TECH TIP

PRODUCT: QUEST JUICE

SUBJECT: CABINET DRAIN TUBE MODIFICATION

DATE: AUGUST 2, 2004

FIGURE 3

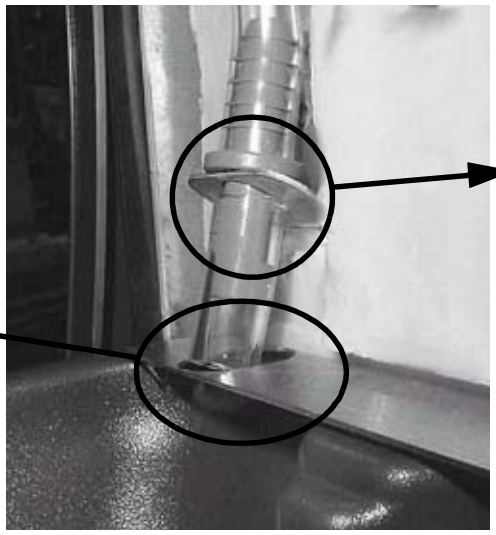
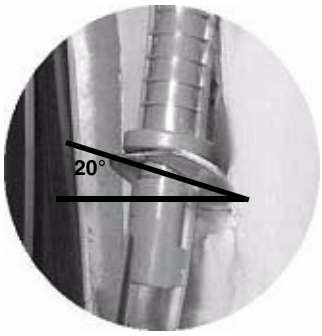
Units built starting the week of May 21, 2004 had a clear tube added to the cabinet drain to assure all condensation from the cabinet ran into the drip tray. Since the length to this tube extended into the drip tray itself, (Figure1) it was necessary to tip the drip tray when replacing it on the unit to assure the tube was completely in the tray. If this tipping of the tray did not happen the tube would be pushed behind the tray and the cabinet condensation would then run onto the counter (Figure 2). The recommended action to correct this is in 2 steps.

1. Bend the drain support bracket up about 20 degrees. This moves the outlet forward so it is aimed at the tray. (Figure 3, Detail B)
2. Cut the extension tube back so it inserts through the bracket but does not interfere with removing and replacing the drip tray itself. (Figure 3, Detail A)

DETAIL A. Tube cut just above the metal plate

DETAIL B. 20 degree bend up on the bracket
